US-APWR DCD Tier 1 Enhancement Project

Tuesday 3/15 AM Handout 4

2.7.5.2 Engineered Safety Features Ventilation System (ESFVS)

Tier 1 Changes Explanation/Basis Document
Tier 1, Section 2.7.5.2

Figure 2.7.5.2-1 Annulus Emergency Exhaust System

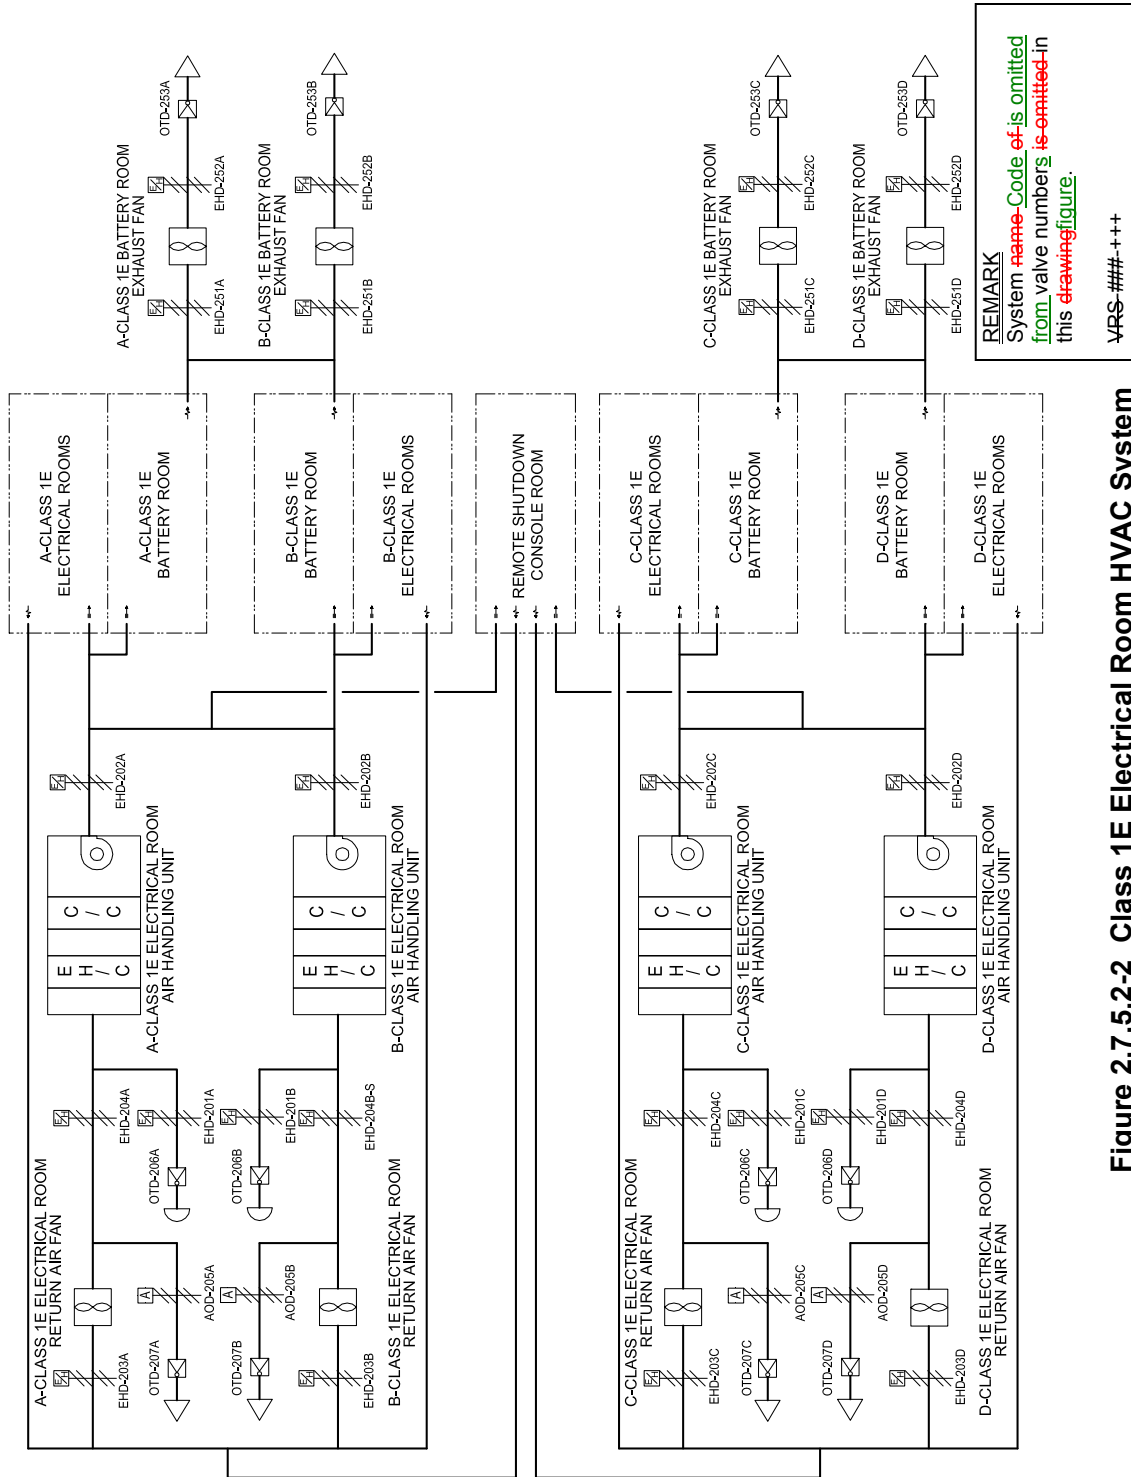
REMARK
 System name Code of is omitted
 from valve numbers is omitted in
 this drawing figure.
 VRS-###-+++

Figure 2.7.5.2-2 Class 1E Electrical Room HVAC System

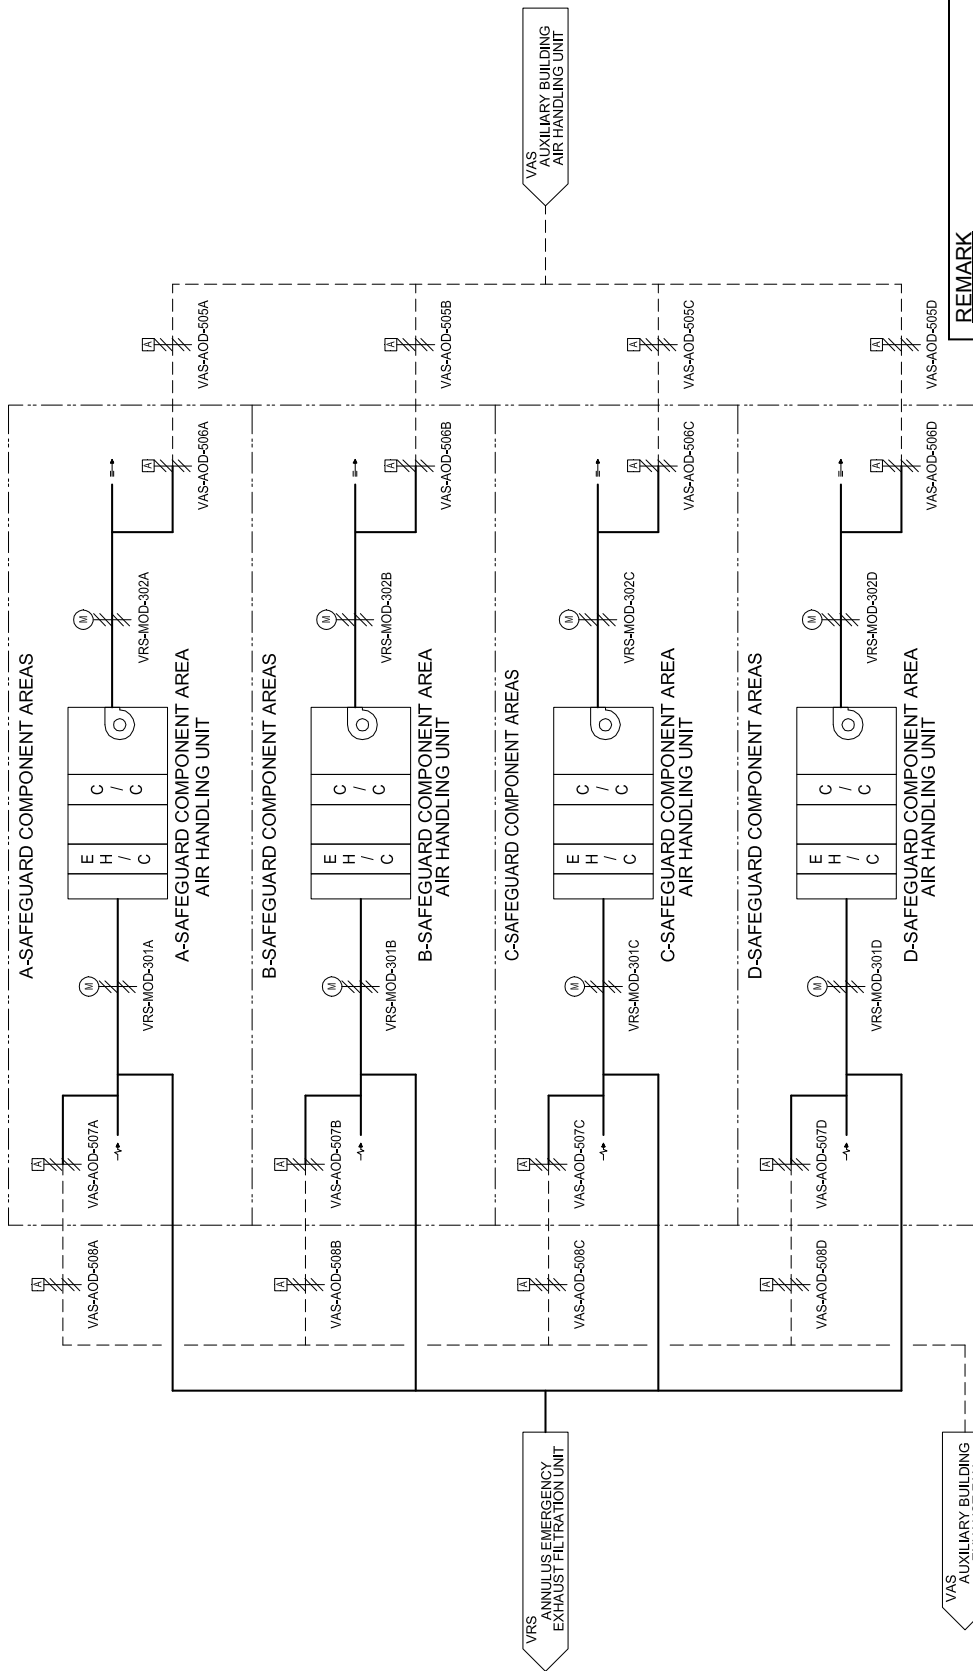
REMARK
 System name Code ~~is omitted~~
 valve numbers is omitted in this
 drawing figure.
 VRS-###-###

Figure 2.7.5.2-4 Emergency Feedwater Pump Area HVAC System

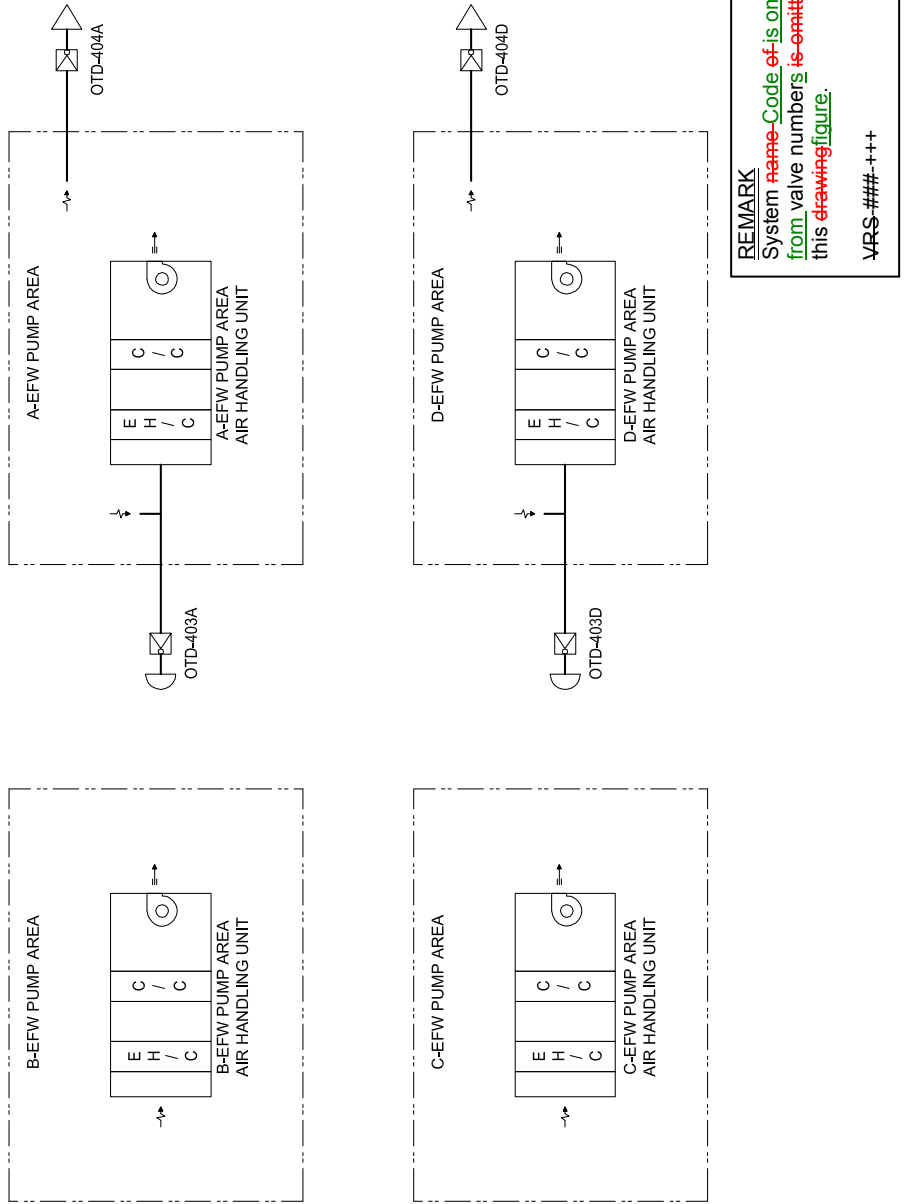
REMARK
 System name Code is omitted from valve numbers is omitted in this drawing figure.
 VRS-##-+++
